N6705A-02B

S E R V I C E N O T E

N6705A DC Power Analyzer

Restricting the movement of the Front Panel FFC Cable

Figure 1. Demonstration of the correct placement of the deflector

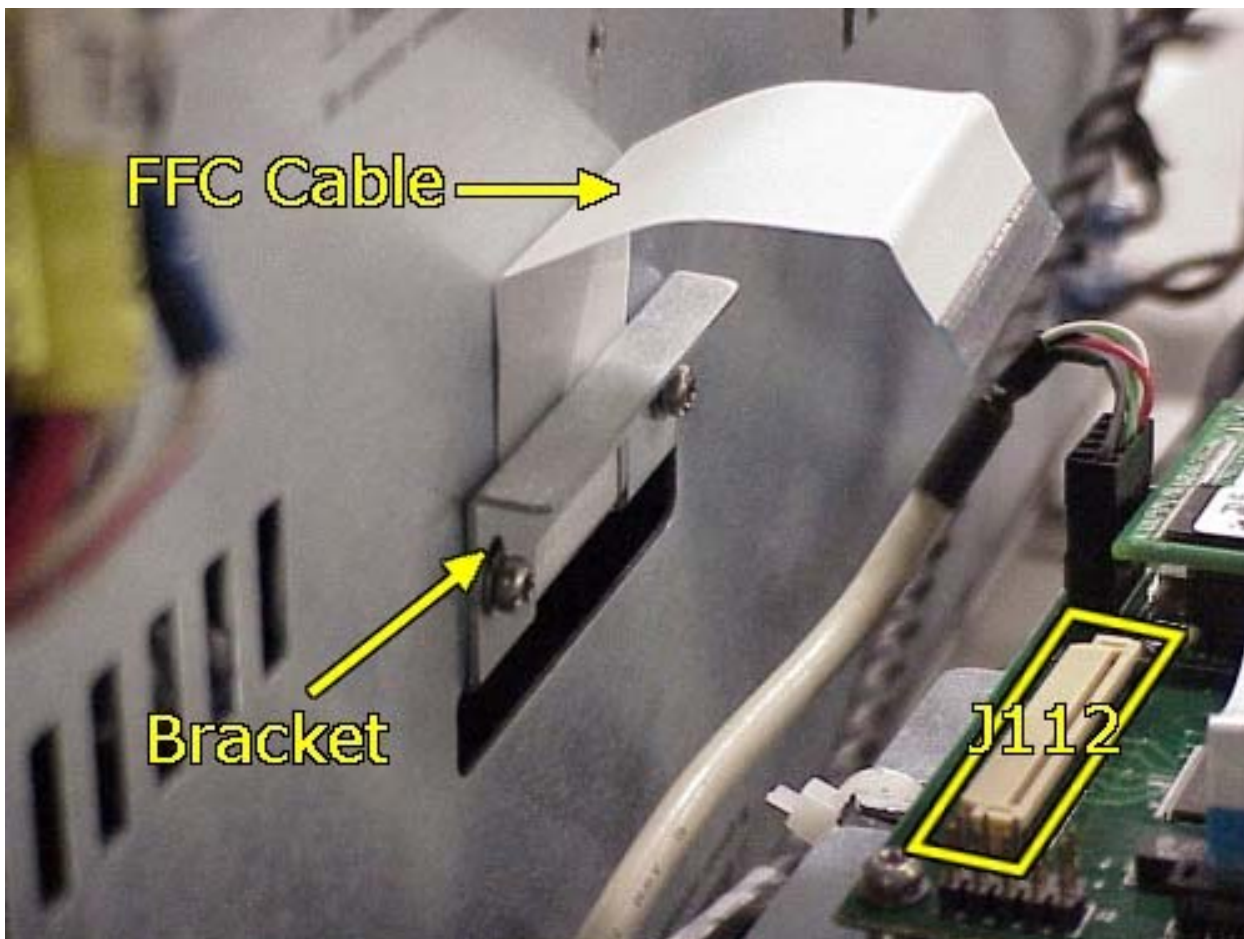
The N6705A unit is missing bracket (P/N 5002-2882) between the front panel FFC cable (P/N 5185-8823) and the connector J112 on the P1000 board (P/N 5022-1209). This causes the connection between the FFC cable and the connector to loosen due to vibration.

If the bracket is not present as show in **Figure 1**, then follow the instructions on page 64-65 of the N6705A in order to separate the front panel from the mainframe.

To eliminate the vibration of the FFC cable it will be secured as shown in the following figures.

Figure 2. Close-up of the grommet that needs to be removed

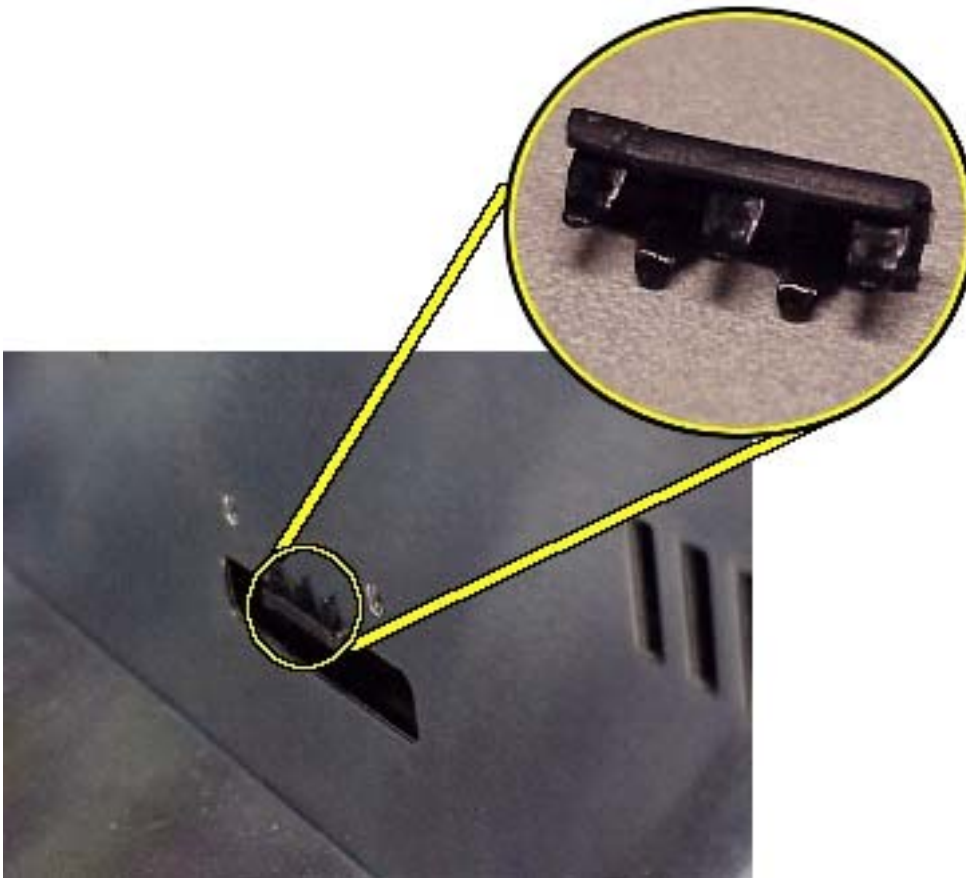
Remove and discard the grommet in **Figure 2** if it is present.

Failure to remove the grommet will damage the FFC cable when installing the bracket
